Arlington High School Building Committee
Finance Subcommittee Meeting
Tuesday, September 19, 2023
Conducted by Remote Participation
4:00 PM – 4:30 PM
Agenda

**9/19/2023 AHSBC Finance Subcommittee Meeting
Meeting Materials**

Change Order (CO)

CCC - CR618R1
DRAWING NUMBER
SKM
107C
JOB NUMBER
6017442

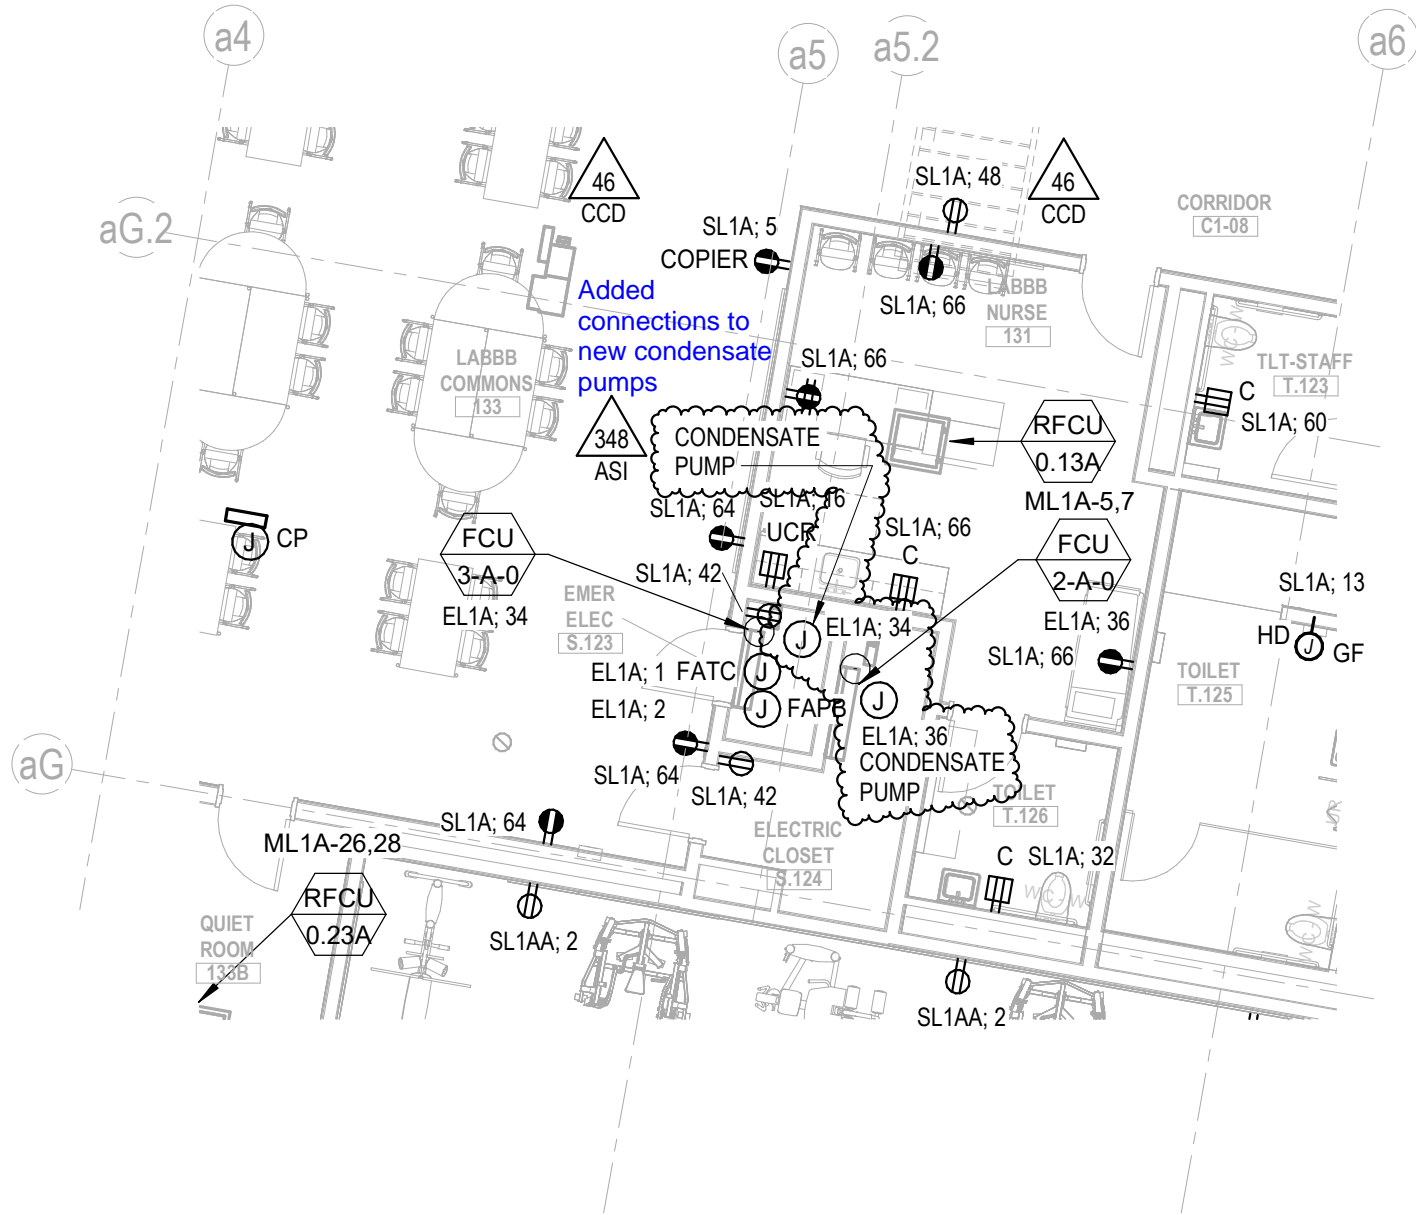
See also RFI-753
REF. DWG. M3.0a ASI-348

Additional costs associated with ASI 348- Condensate Piping Changes in Area 1A

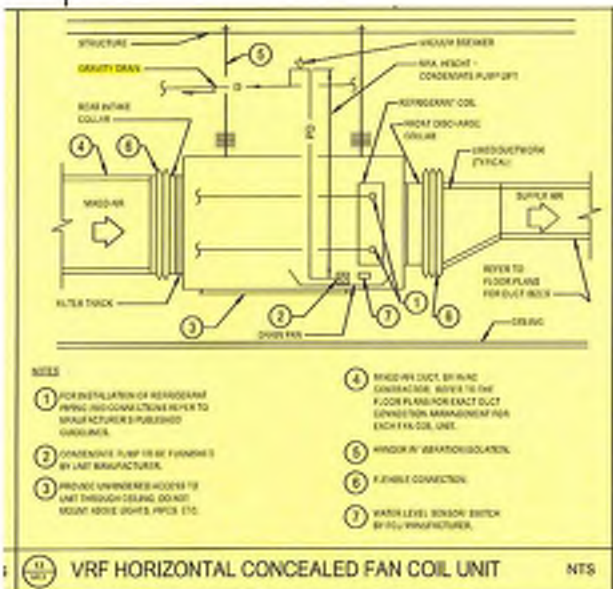
RFCU's condensate drains: Since Detail shows condensate drain: some quantity of drain pipe would be assumed required. The route is not indicated on the drawings and so LF/size takeoff could not be quantified fully during Bid... Generally, the routing shown for the 3/4" RFCU condensate drains is the shortest reasonably inferable route/LF.

The interior HRU also would be assumed to have a condensate drain, however, since there is no detail specifically for interior HRU units it is understandable that bidding might not have anticipated the pipe need and size.

We propose that the costs associated with the HRCU units drains (3/4" pipe, labor/ insulation matts and labor be negated due to the drain being owned in the detail 13/M0.3 and the routing being shortest reasonable assumed routing. We propose that the costs associated with the 1 1/2" drain from the HRU-14 be maintained as an added cost.

Addition of Fire Smoke Dampers

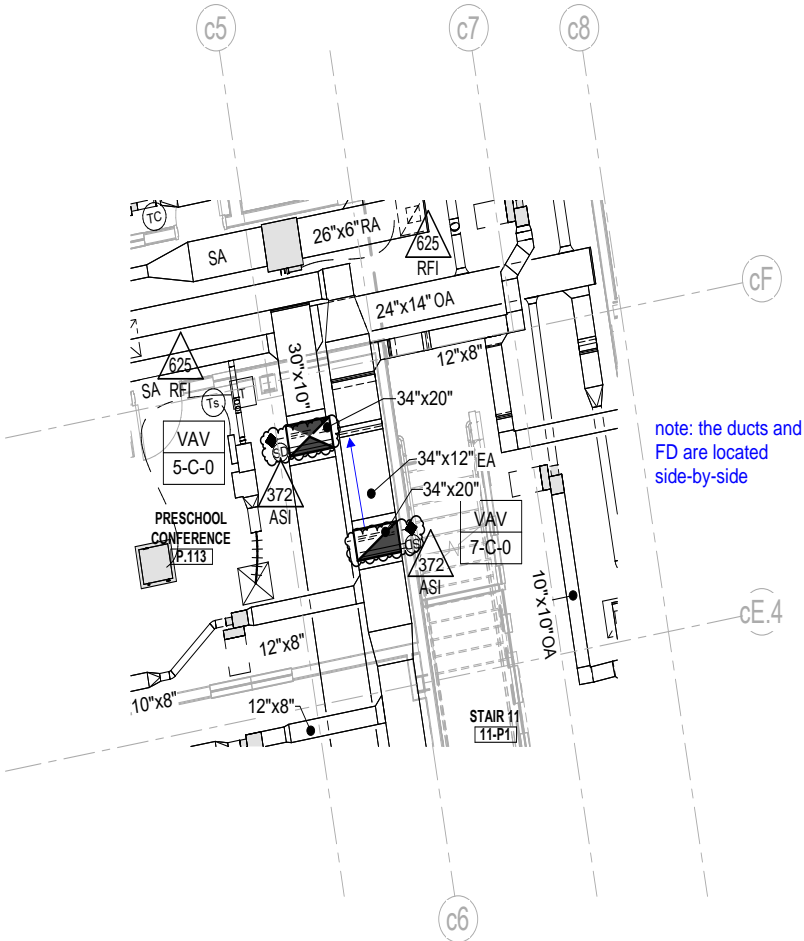
The Work shall be carried out in accordance with the following Supplemental Instructions issued in accordance with the Contract Documents without change in Contract Sum or Contract Time. Proceeding with the Work in accordance with these instructions indicates your acknowledgement that there will be no change in the Contract Sum or Contract time.
